*4.2.1. Position determination*  
*Proposed modifications*

AECS 12<sup>nd</sup>. meeting  
Moscow, 9-11 February 2016

Figure 4 – Diagram of path calibration

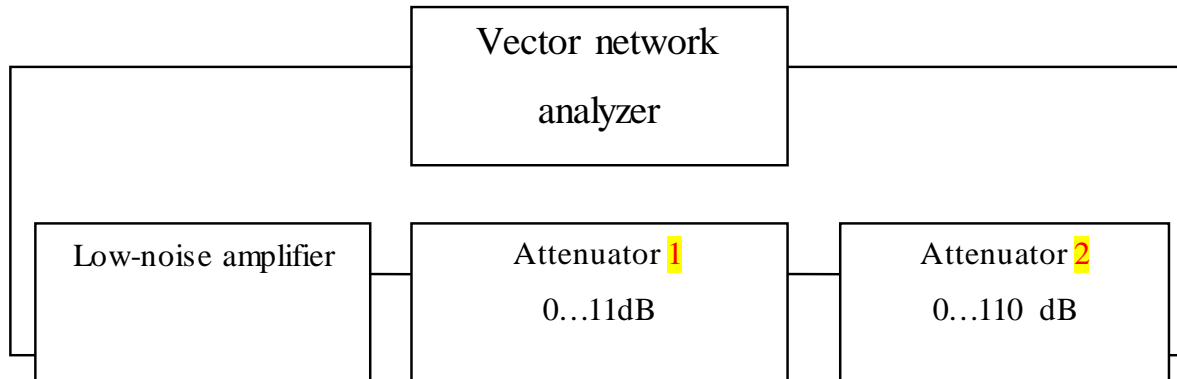
- 2.1 – It should say: **GNSS receiver** (*instead of navigation receiver*)
- 2.1.6 – It should say: **GNSS receiver** (*instead of navigation receiver*)
- 3.5.2 – It should say: **GNSS receiver** (*instead of navigation receiver*)
- 3.7 – It should say: **GNSS receiver** (*instead of navigation receiver*)
- 3.7.4 – Figure 5 should say: **AECD/AECS** (*instead of The AECD*)
